## **GROVE FARM**

### **TRANSPORTATION & HIGHWAY SUPPLEMENTARY REPRESENTATIONS**

**HIGHWAYS ENGLAND  
DEVELOPMENT CONSENT ORDER APPLICATION (DCO)  
FOR  
M25, JUNCTION 28 IMPROVEMENT SCHEME**

**Redwood Reference: PMcL/3396d2/March 2021**

Drawing No. REDW-3396-115– Amended Grove Farm Access Overview

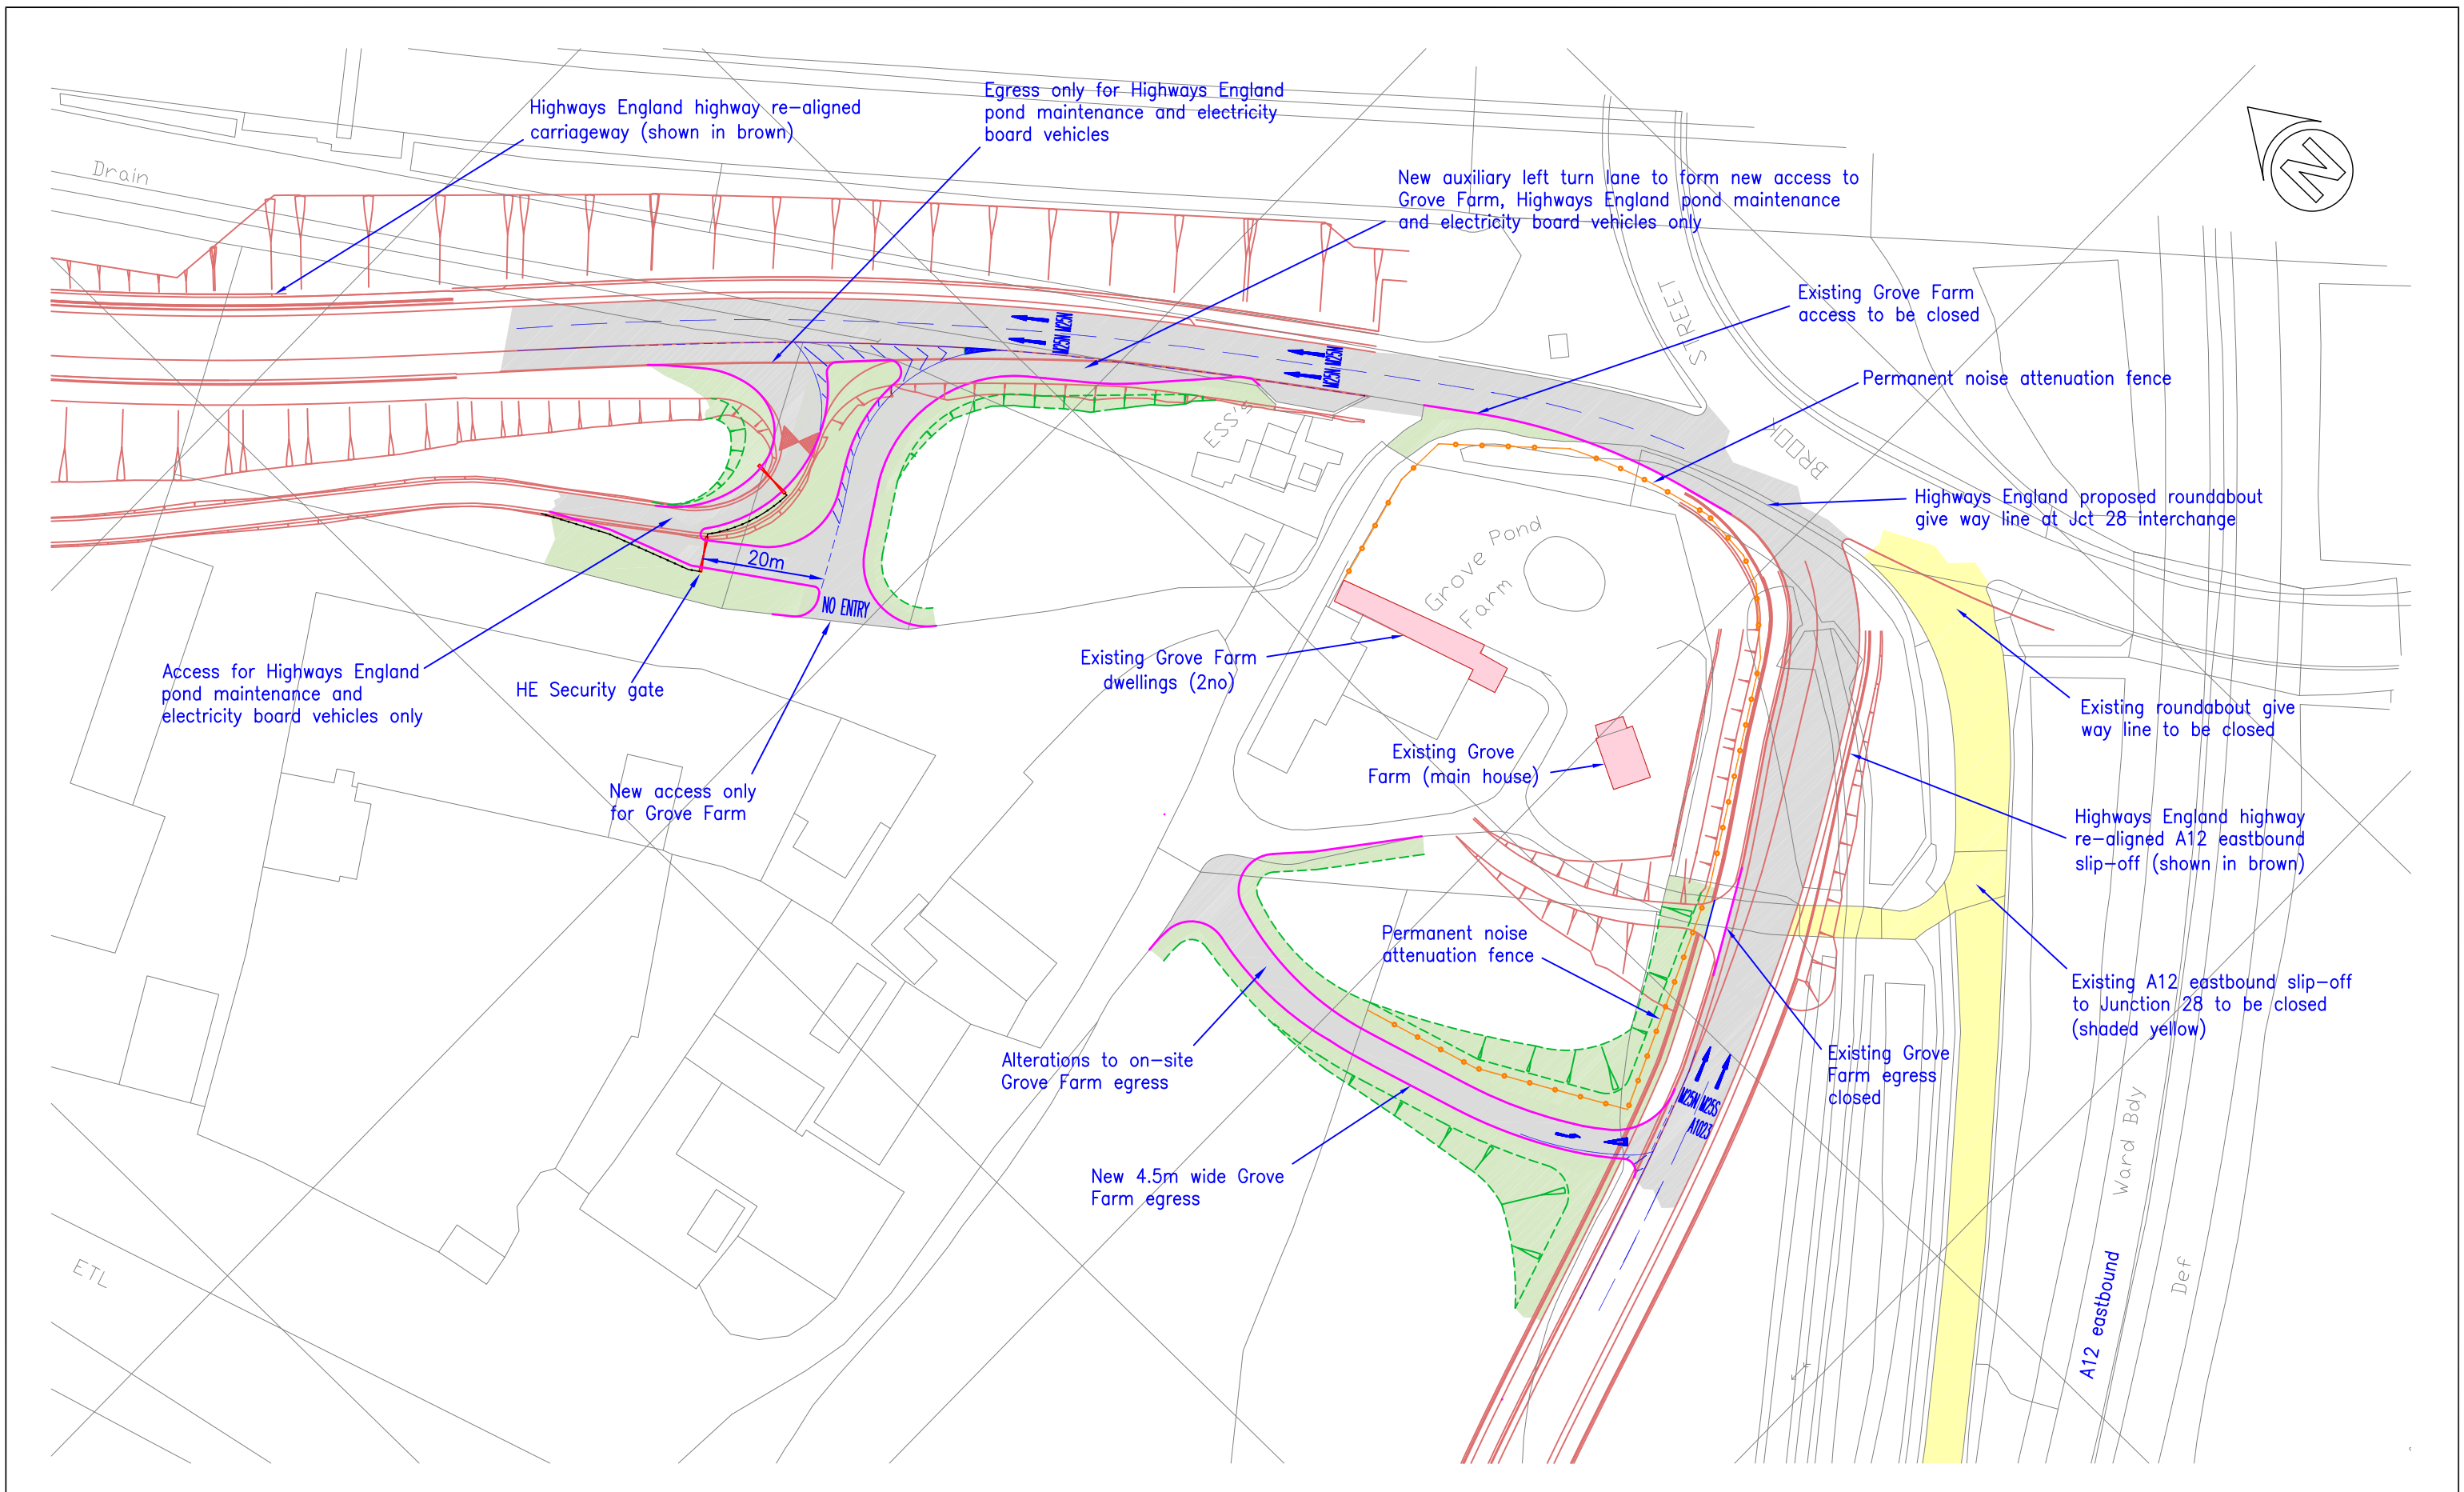
- 1.2 After further consideration of comments made by all parties during the Hearing, we have now prepared **Drawing No. REDW-3396-115** showing our suggested and amended improvements to the HE Scheme surrounding Grove Farm. **Drawing No. REDW-3396-115** shows the HE proposals at an adequate scale and establishes the position of the HE Scheme relative to the location of the three dwellings on the Farm. The existing A12 eastbound off-slip (shaded yellow on the plan) will be closed as part of the HE Scheme. The new alignment of the A12 eastbound off-slip will be located significantly closer to the existing dwellings (shaded grey on the plan).

- 1.4 The owners of Grove Farm have concerns that no permanent noise mitigation measures are included in the HE Scheme surrounding Grove Farm. To rectify this omission my **Drawing No. REDW-3396-115** shows the suggested location of permanent noise attenuation fencing surrounding the properties which would contribute towards mitigation of increased environmental traffic noise brought about by the HE Scheme. We request that HE include in an amended HE Scheme permanent noise mitigation measures surrounding Grove Farm as shown on my **Drawing No. REDW-3396-115**.

- 2.1 The location of the existing Grove Farm access is already a significant departure from highway design standards by its location close the north-west egress of the roundabout. HE stated at the formal Hearing that their proposals do not affect the existing access to Grove Farm from the M25 northbound slip, therefore no alteration to Grove Farm access is necessary. We do not agree that the HE Scheme does not affect the existing Grove Farm access.

- 2.2 The HE Scheme introduces new safety concerns in that the access to Grove Farm is now immediately after the M25 northbound exit from the roundabout relative to the new alignment of the A12 eastbound off-slip. Currently, the existing access is approximately 30 metres from the northbound exit from the roundabout. This reduction in the separation between the site access and the roundabout brought about by the HE Scheme will introduce new road safety issues whereby a road user signaling can be misinterpreted by following vehicles. Road users indicating left to exit a roundabout may not have sufficient time to cancel their indicator and re-indicate before turning left from the main road. This could result in following road users failing to anticipate the left turn manoeuvre by the proceeding vehicle increasing the risk of late braking and/or rear end shunt type collisions.

- 2.3 We still maintain that our proposal to close the existing access into Grove Farm and relocate the Grove Farm access a short distance north beyond the electrical sub-station layby will provide a safer access for the farm and at the same time can be combined with the proposed access for the HE pond maintenance vehicles and electricity board vehicles providing a safer access for all.

- 2.4 Given the new safety issues arising from retaining the Grove Farm access in its present location, we can see no practical reason why the relocation of the Grove Farm access could not be facilitated as shown on my **Drawing No. REDW-3396-115**. My proposals will not introduce any new conflicting vehicle crossing movements and will provide a safer access for the farm and no egress onto the M25 northbound on-slip for farm traffic.

- 2.5 The proposed relocated site access off the M25 northbound on-slip has a short deceleration length and is a departure from design standards, however overall I and the

Grove Farm safety audit team consider there would be a nett benefit in road safety terms when compared to the existing Grove Farm access arrangements as the new access would be further away from the roundabout. M25 northbound on-slip vehicle speeds would still be relatively low as the relocated access is marginally further north of the existing farm access. HE confirmed at the Hearing that whilst the formal speed limit of the on-slip is 70 mph, the Design Speed for this section of road is 70kph (44mph) reflecting the fact that vehicle speeds will still be low (i.e. less than 40mph) leaving the roundabout.

- 2.7 Notwithstanding these satisfactory track drawings, HE commented that the distance between the security gates and the access to the farm could result in a vehicle of exceptional length waiting in front of the gates which could block traffic entering the farm. A straight-forward engineering solution to this issue is shown on **Drawing No. REDW-3396-115** whereby the distance between the pond access security gates and the farm access has been increased to 20 metres; more than adequate to safely contain any size of vehicle legally allowed to use UK roads.

- 3.1 Grove Farm's previous submission suggested providing a new access into Grove Farm from the A12 eastbound off-slip, combined with the Grove Farm egress. After further consideration of comments received during the Hearing, the proposals have been amended to remove the request for a new access to Grove Farm from the A12 eastbound off-slip.

- 3.2 The proposal shown on my **Drawing No. REDW-3396-115** now removes a new access, however the proposal includes a relocation of the existing Grove Farm egress further west which will have the following benefits:

- i) The current location will result in Grove Farm traffic leaving the site queuing directly outside the Grove Farm main house as the distance between the farmhouse and the A12 off-slip has been significantly reduced. The relocation will move this queuing traffic further away from the farmhouse;

- ii) The relocated egress will allow for the inclusion of a reasonably sized landscaped area between the farmhouse and suggested noise attenuation fencing;

- iii) Traffic leaving the farm heading south on the M25 will be provided with more distance to adequately cross to the right-hand lane when approaching the roundabout.

- 2.8 All land required for the amended farm access proposals from the M25 northbound on-slip is either in the ownership of HE or Grove Farm. Given the amended proposals shown on **Drawing No. REDW-3396-115**, we request that HE include in an amended HE Scheme:

- i) Closure of the existing access to Grove Farm from the M25 northbound on-slip;
  - ii) Construction of a new dedicated auxiliary left-turn lane access to Grove Farm from the M25 northbound on slip road to be shared with the HE service access already proposed for pond maintenance and electricity board vehicles.

- 3.3 All land required for the amended farm egress proposals onto the A12 eastbound off-slip is either in the ownership of HE or Grove Farm. Given the amended proposals shown on **Drawing No. REDW-3396-115**, we request that HE include in an amended HE Scheme:

- i) Closure of the amended egress from Grove Farm to the A12 eastbound off-slip;
  - ii) Construction of a new dedicated egress from Grove Farm to the A12 eastbound off-slip with alteration of on-site roads to suit.
